WHEREAS, on October 23, 2006, by Roll Call No. 06-2090, it was duly resolved by the City Council, that the City Council consider a proposal from Hubbell Realty Company, represented by Steve Niebuhr (officer), to rezone certain property located in the vicinity of 31st Street and Carpenter Avenue from the "R-3" Multiple-Family Residential District classification to the "PUD" Planned Unit Development District classification, and to approve a "PUD" Conceptual Plan for the development of two five-story student apartment buildings in the block bounded by Forest and Carpenter Avenues and by 30th and 31st Streets, and a three story student apartment building in the block bounded by Carpenter and University Avenues and by 31st and 32nd Streets, and that such proposal be set down for hearing on November 6, 2006, at 5:00 P.M., in the Council Chambers at City Hall; and,

from the "R-3" Multiple-Family Residential District classification to the "PUD" Planned Unit Development District classification; and,

Subject: Drake University Housing and Parking Expansion
31st Street and Carpenter Road
Des Moines, Iowa

PRELIMINARY CONCEPTUAL PLAN FOR DRAKE-HUBBELL HOUSING
A PLANNED UNIT DEVELOPMENT IN THE

CP2.2

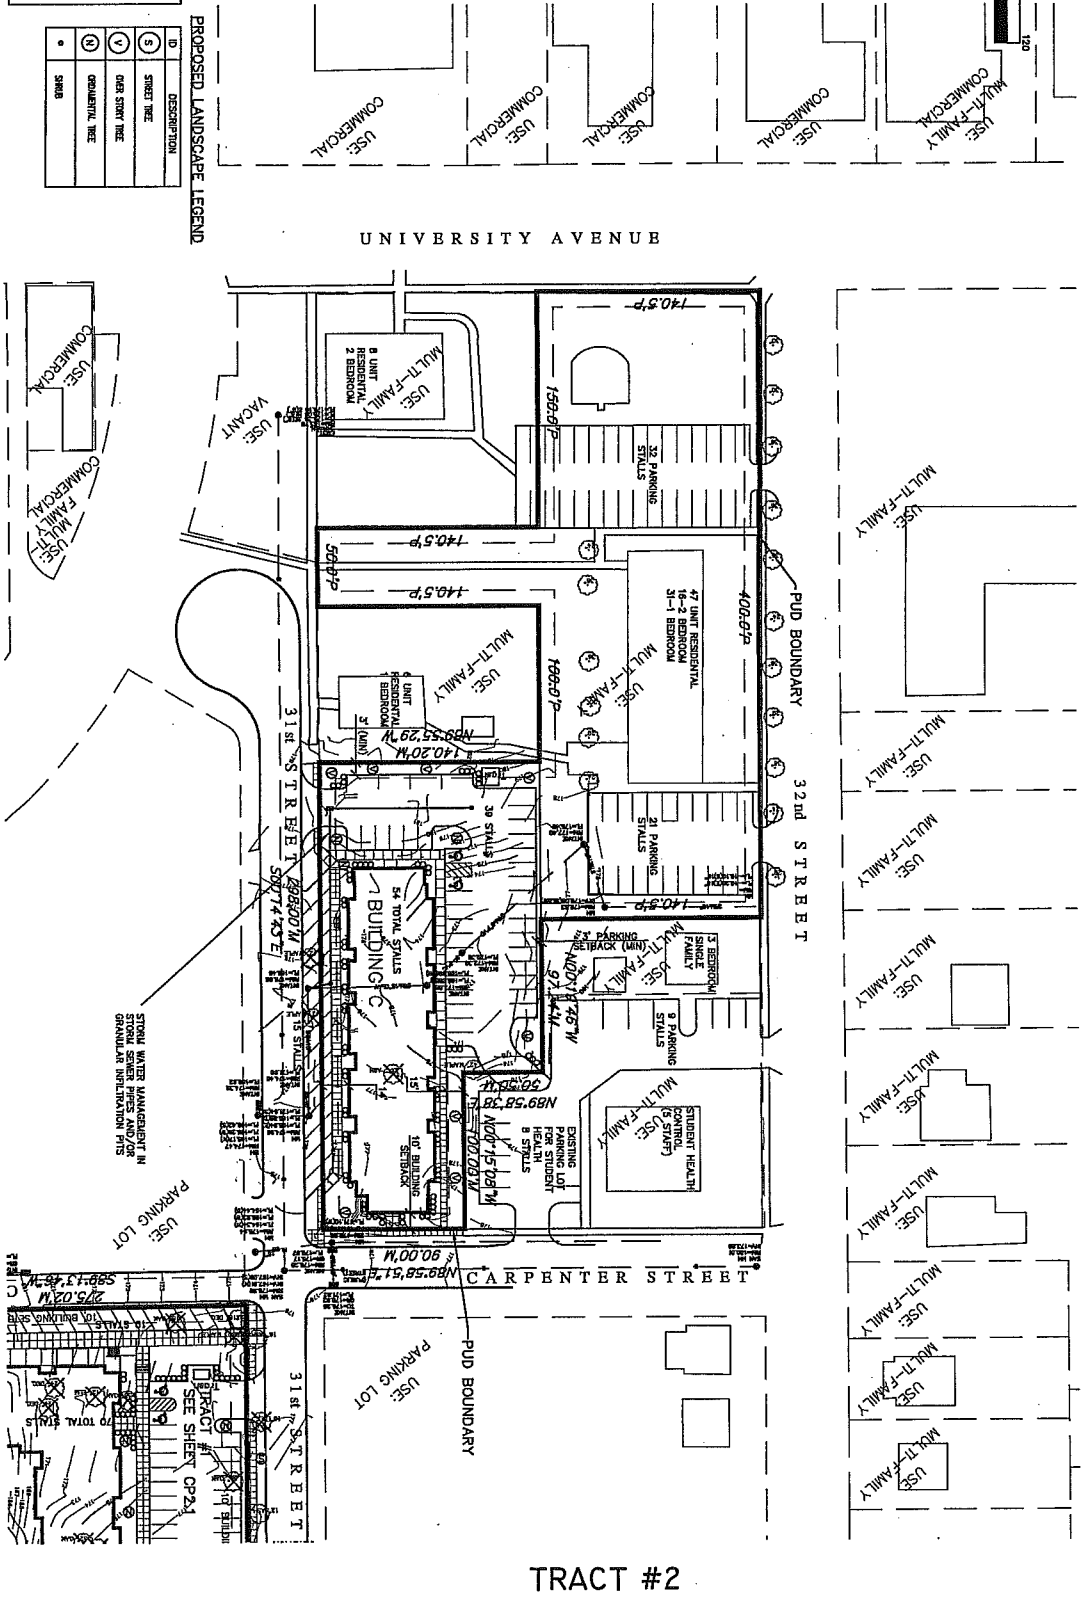
In reviewing the plan, staff believes there is some potential to save a few of the large Oaks in the western parking lot on the north block. Staff also believes that a tree for tree replacement of new plantings to mature tree removed should be required within the overall site and that notes should be added to the plan to ensure protection of trees to be saved during the demolition, site preparation and construction.

Traffic staff did recommend that the alignment of the sidewalk along the north side of Carpenter Street should be adjusted to direct pedestrians as close as possible to the 30th Street crossing and the alignment of the sidewalk connection on the east side.

Tim Urban: Asked about tree retention in the staff recommendations; asked which trees are identified to retain. Suggested some minor modifications of the orientation of the buildings or placement of the parking lots may allow preservation of some of the large over-story trees.

1. Provision of a note requiring mitigation for removal of any mature over-story trees on a tree for tree (quantity) basis, with the following tree protection language added to the plan for mature trees that are identified to remain:

3. Revise the alignment of the sidewalk along the north side of Carpenter Street to direct pedestrians as close as possible to the 30th Street crossing.

3. Revise the alignment of the sidewalk along the north side of Carpenter Street to direct pedestrians as close as possible to the 30th Street crossing.

North Building Site
 Tract 1 - South Elevation - Building '9a'
 Scale: 1/8" = 1'-0"

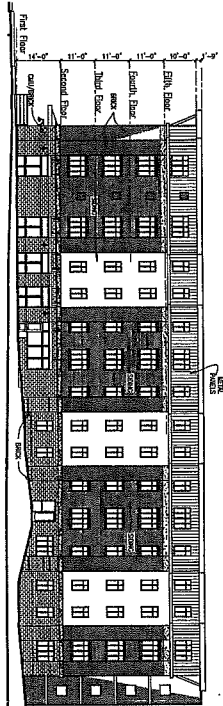
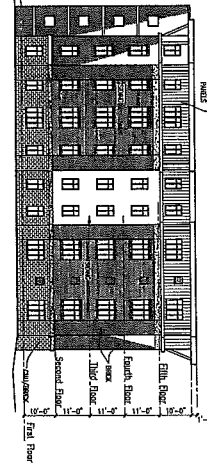
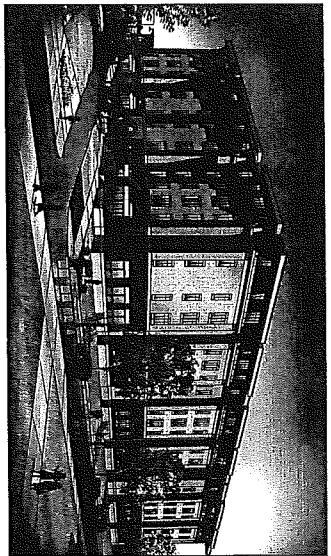
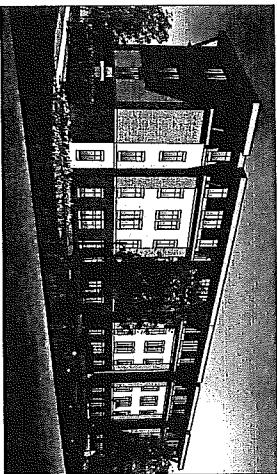
Staff does not believe that the maximum height limitation of 70' is necessary based on the conceptual elevations of the buildings. A 60' height maximum should be sufficient. Notes should be provided requiring the screening of all rooftop mechanical equipment from view on adjacent streets.

Brian Millard: Asked if antennas or cell towers would be allowed on top of the building.

Casey Port, Hubbell Realty: Noted the roof elevation is just under 60' and they would still ask to add a note to the plan allowing antennas etc. no more than 15' above the roofline, but they will not have a lot of rooftop mechanical equipment; all units have prepackaged mechanical units. Regarding the commercial space, the intent is that retail uses would support the students and the students would like those businesses to be allowed to operate later in the evening. Uses being considered are coffee shops, duplicating and copying and postal services with 24-hour operation. Noted the Drake University Board met and approved a situation that a tax-exempt foundation would own the structure.

6. Revise the maximum height from 70' to 60'.
 7. Addition of a requirement that all rooftop mechanical equipment shall be screened from view on adjacent streets.

5. Revise the maximum height from 70' to 60'.
 6. Addition of a requirement that all rooftop mechanical equipment shall be screened from view on adjacent streets.
